Access Compliance Report

Public Rights-of-Way

(Curb Ramps)

Intersection ID: 21469	Main Street: HOLLY_LN	Cross Street: NEWMANS_LN	Location: S
ADA ID: 0EF3550AE236	Ramp Type: BlendTrans2	Initial Pass/Fail: Fail	Overall Compliance: No
Severity Score: 8.75			
Codes/Mitigation Info/Possible Solution		Field Measurements/Component Compliance

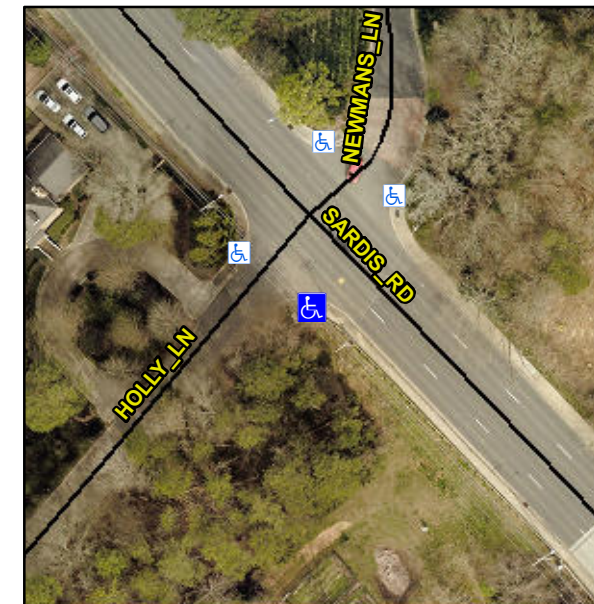
Not Found, R304.5.1

Remove & Replace Curb Ramp With Two New Directional Ramps or Equivalent.
